DG Flugzeugbau GmbH
76646 Bruchsal

Service Info
No. 55-04

Subject : Landing gear control – side cover in rear cockpit

Effectivity : DG-1000S, all ser. no.'s

side cover in rear cockpit left hand side, front part

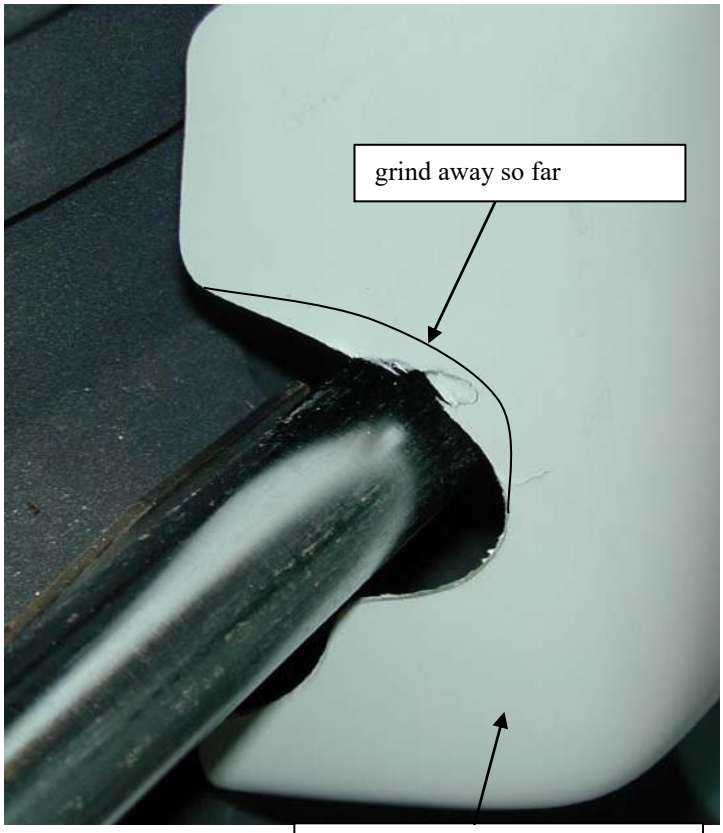
Reason : If the landing gear operating handle is rotated very far into the cockpit, the locking latch at the push rod may interfere with the side cover.

Instructions : Extend the landing gear so far, that the locking latch is located directly at the side cover. Rotate the operating handle and mark it's position on the side cover. Remove the side cover and grind away so much, that the locking latch has 3mm clearance in it's most unfavourable position, see sketch.
